Manual Supplement

Manual Title: 345 Users
Part Number: 2560401
Print Date: October 2006
Revision/Date:

Supplement Issue: **6**
Issue Date: 8/13
Page Count: 3

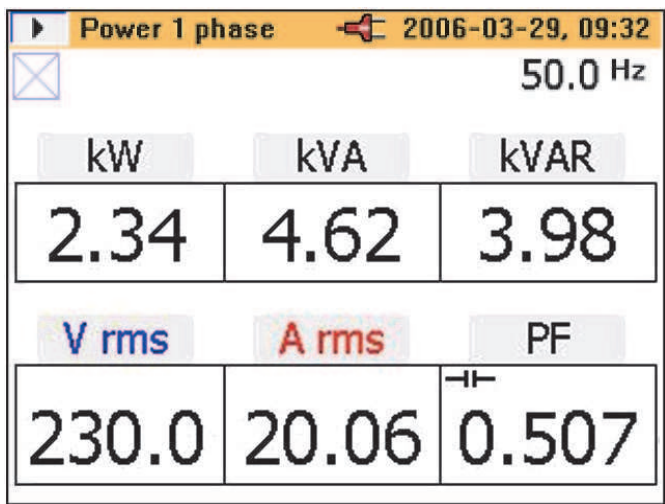
On page 55, remove the screen shot and replace with the following:
